Re: Response to Third Technical Notice of Deficiency (TCEQ Tracking No. 27435345)  
City of Victoria Landfill (Type I)  
Victoria, Victoria County, Texas  
CN600243257/RN100212968  
Proposed TCEQ Permit Number MSW-1522B  
Major Amendment Permit Application

On behalf of the City of Victoria, Burns & McDonnell is submitting the enclosed response to the third technical notice of deficiency (NOD) provided via email on January 6, 2023 from the Texas Commission on Environmental Quality (TCEQ) for the City of Victoria Landfill application. The permit application has been revised to address the NOD comments. The NOD comments and associated responses are provided in the following NOD table.

project	107608	contract	-
drawing	III.A1.5	rev.	3
sheet	6	of	25
file	107608III.A1.5.dwg	sheets

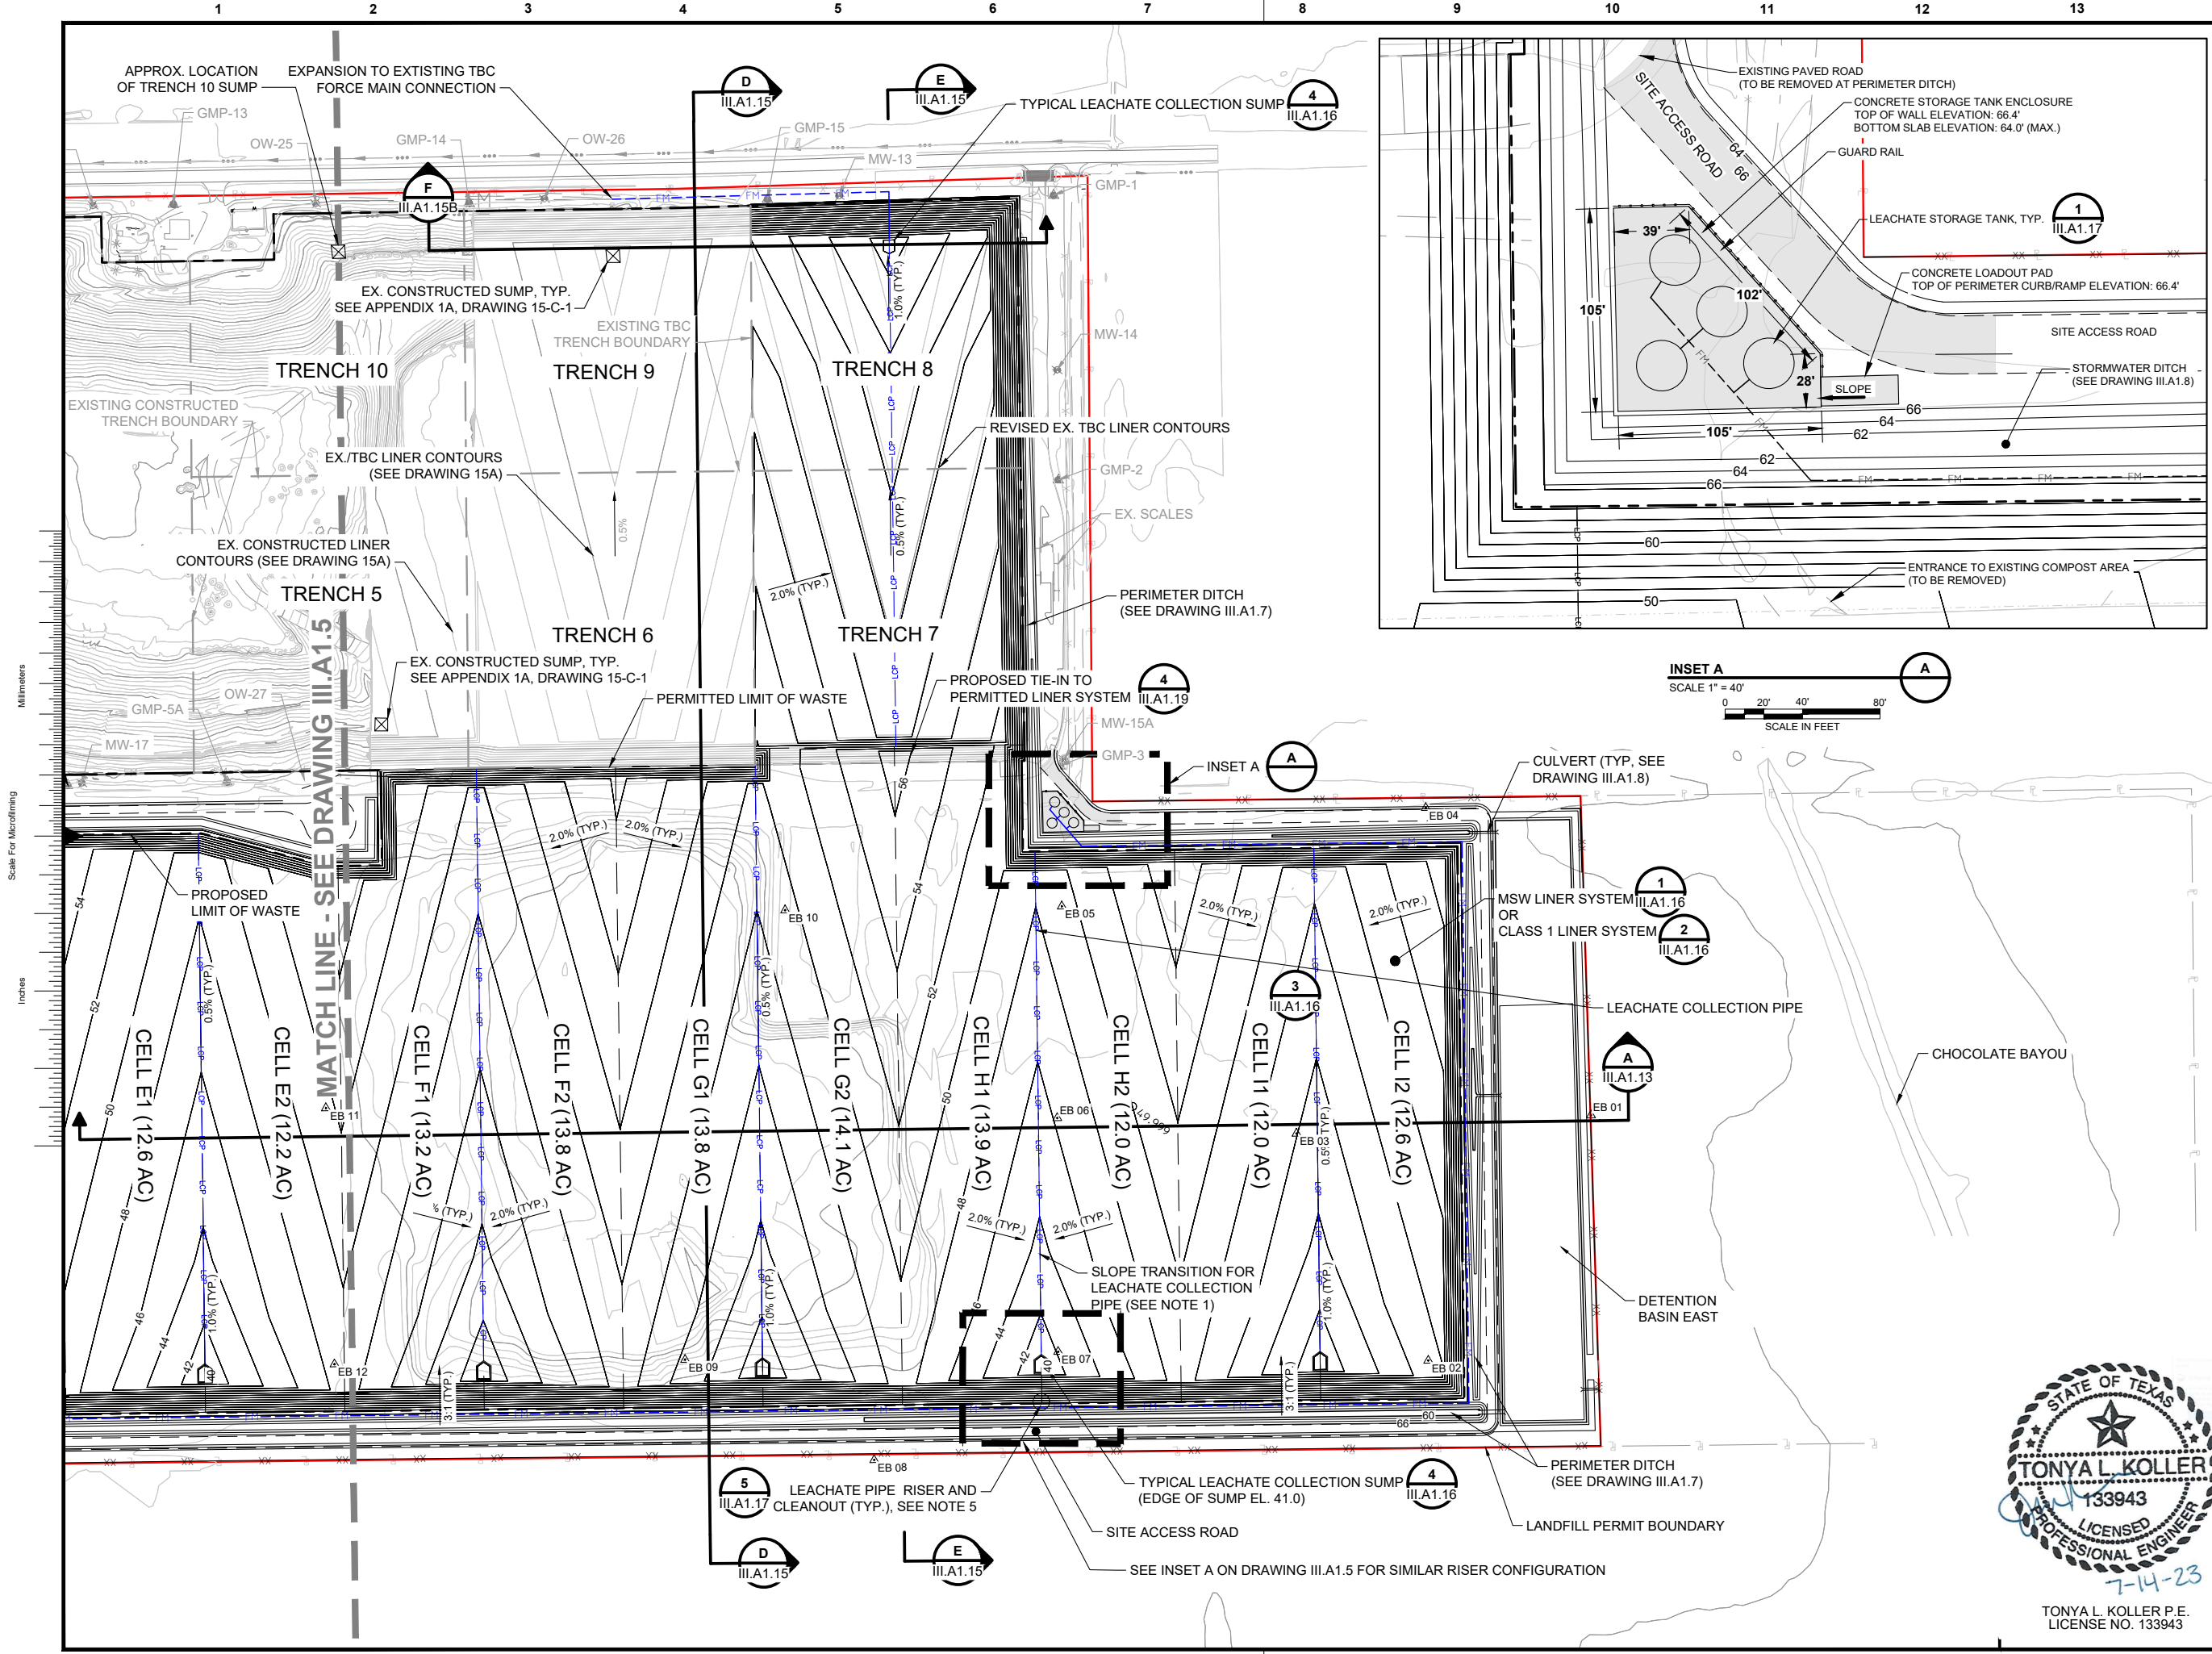
NOD ID	NOD Description	Response
T1 (T3)	<i>(Regarding the response to T3 of the second NOD) For clarity, revise Drawings III.A.1.5 and III.A.1.6 to use an appropriate symbol/legend to show locations of the leachate pipe risers and cleanouts for each sump. Also, revise these two drawings by adding a note stating that the leachate pipe risers and cleanouts for sumps in the developed areas (including, but not limited to, Trench 5) will remain accessible for operation and maintenance throughout the closure and post-closure period.</i>	Drawings III.A1.5 and III.A1.6 in Attachment III-1 have been revised to clearly depict the leachate pipe risers and cleanouts for each sump through revised symbology and the addition of detail insets. Additionally, the notes on these drawings have been revised according to this comment.
T2 (T7)	<i>(Regarding the response to T7(a) of the second NOD) The response states that Outfall Southwest will continue to function post-expansion; and "Table 5-1 has not been updated as calculations have not been completed for existing permitted outfalls, but reference to historic drainage calculations in Appendix 2B have been included for reference." Page Attachment 2-5 is revised to state, "Outfall Southwest consists of partial final cover and partial TBC landfill, with stormwater discharging Outfall Southwest from an existing detention pond." Revised Drawing III.A2.4 appears to show that runoff from Sub-Basin 4-1 will discharge into a ditch that discharges into the existing detention basin Southwest. Since the east portion of Sub-Basin 4-1 will be part of the vertical expansion area, discuss how surface drainage from Sub-Basin 4-1 will differ from the currently approved condition (pre-development condition); and revise the application (design, text, and drawings) as necessary. Also, discuss the drainage condition for the rest of Basin 4; and revise as necessary.</i>	Attachment III-2 has been revised to address how previously approved discharges from Sub-Basin 4-1 will be affected by the proposed expansion design.

project 107608	contract -
drawing III.A1.12B -	rev. 3
sheet 13B	of 25
file 107608III.A1.12B.dwg	sheets

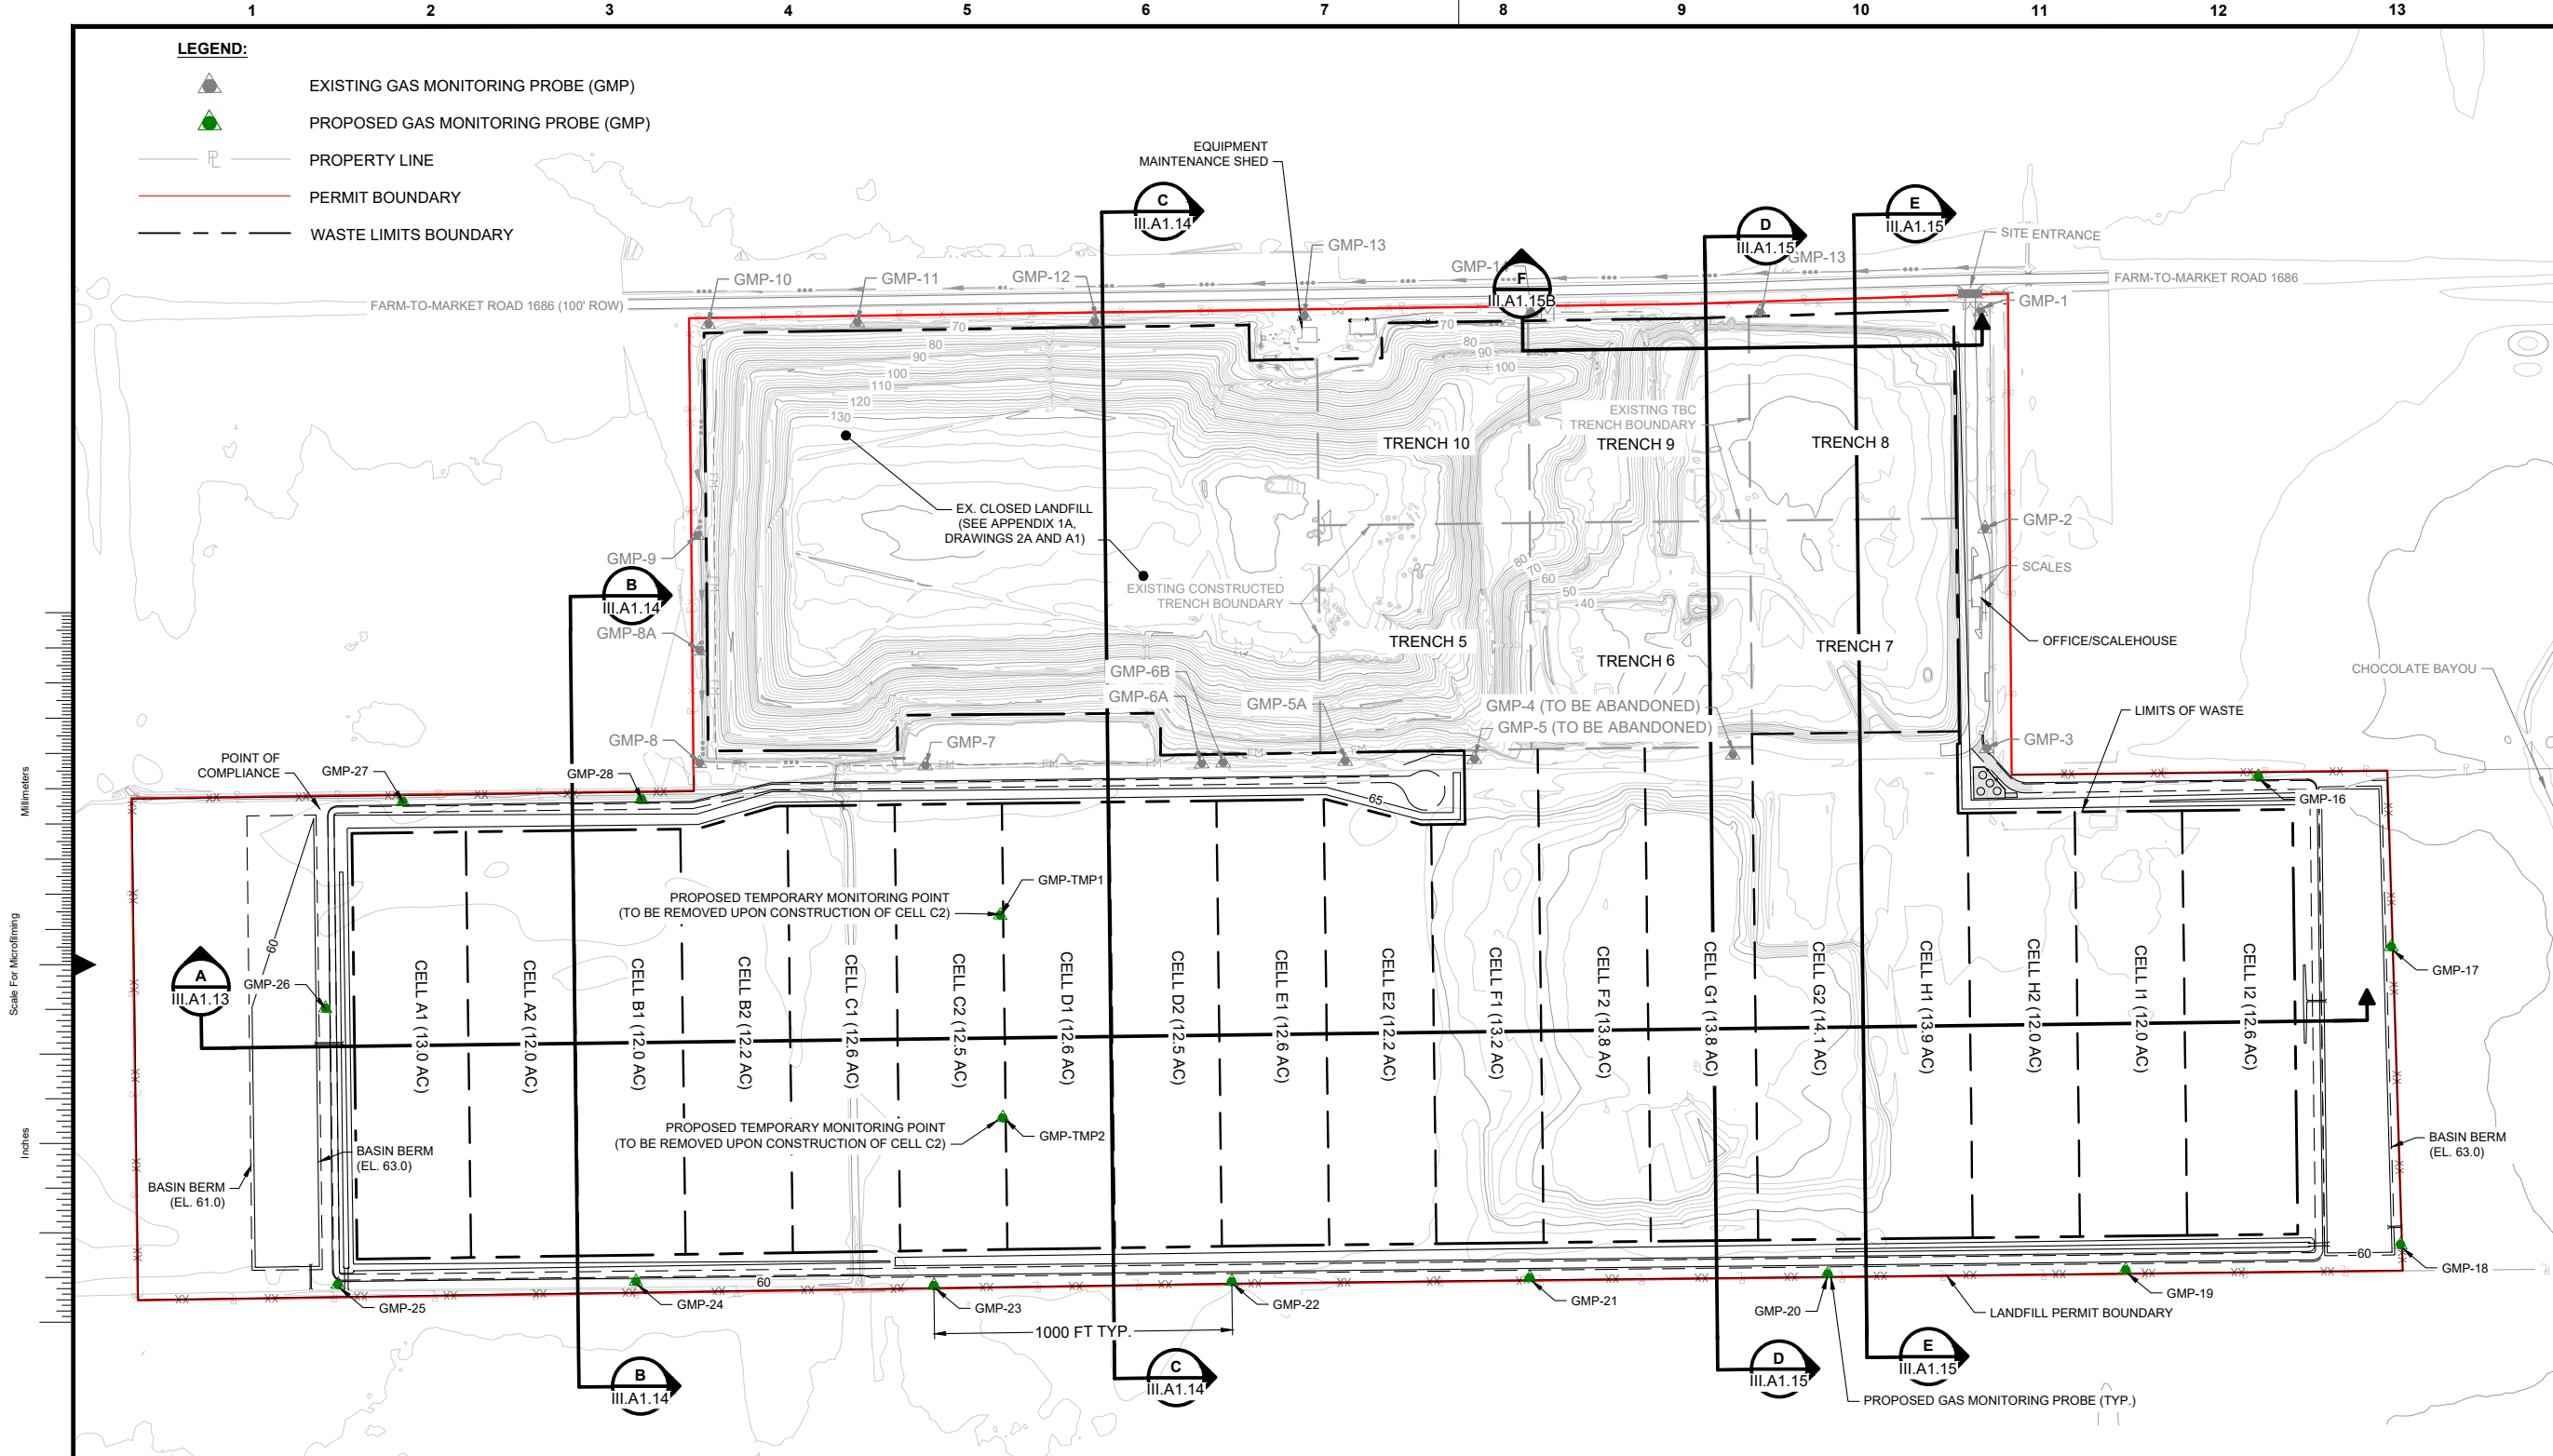
NOD ID	NOD Description	Response
T9 (T19)	<p><i>Provide information on sitewide static water level, based on integrated data from new piezometers and pre-existing monitoring wells.</i></p> <p><i>This deficiency has not been addressed. The annotation of static water level shall be on the geologic cross-sections required under 330.63(e)(4)(G).</i></p>	<p>The cross sections provided on Drawings III.A1.13 to III.A1-15B in Attachment III-1 have been revised to depict the seasonal high static water level, based on interpretations from the historical highest measured level of borings and groundwater monitoring wells (between 2007 and 2019). Ancillary to this change, the groundwater contours displayed on Drawing III.A1.12 have been revised to also reflect this seasonal high static water level.</p>
T10 (T24)	<p><i>Provide a monitoring system dedicated to groundwater.</i></p> <p><i>This deficiency has not been addressed. Provide a dedicated groundwater monitoring system, uncluttered from other information, in accordance with 330.63(f)(1).</i></p>	<p>Drawing III.A1.12 in Attachment III-1 has been revised to establish a focus on the groundwater monitoring network; gas monitoring probes (and references thereof) have been removed. The Drawing title has been changed accordingly. Drawing III.A1.12B has been established to depict the gas monitoring probes.</p>
